Re: Inspection Letter: RHF059 Spec Lot 59 The Retreat at Hook Farms 1st Plat – 2118 SW Red Barn Ln., Lee’s Summit, Missouri

Vista Structural Engineering, LLC was asked to address the following rough-in inspection items for the project located at above referenced address. Please see the following responses w/ attached documentation, and site photos for reference.

Figure 1 – Installation locations of post caps

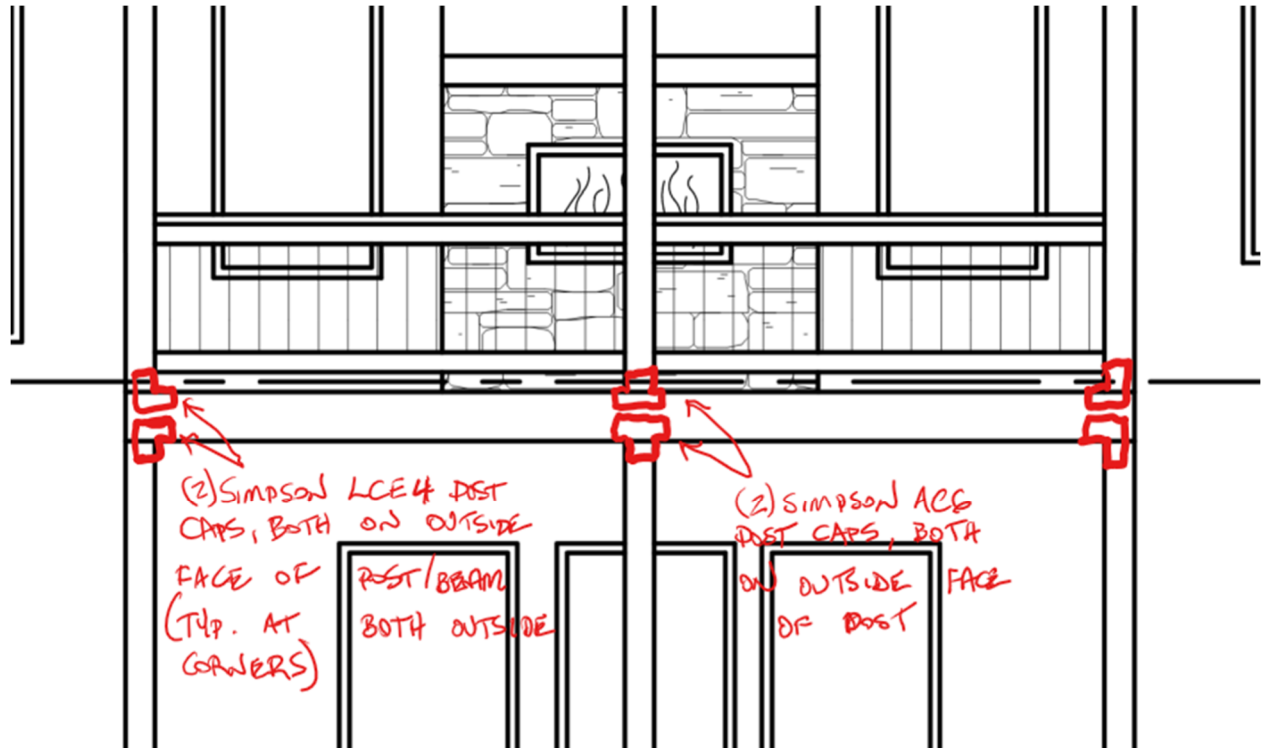
- 1) **Inspection comment:** “Address deck post to beam connection. See attached pictures of the 3 post to beam connections.”

Vista Structural’s response: *We recommend adding two LCE4 post caps at the outer face of the two corner posts and two AC6 post caps at the outer face of the interior post. A sketch has been attached on the following page for clarification, and pictures on the following pages.*
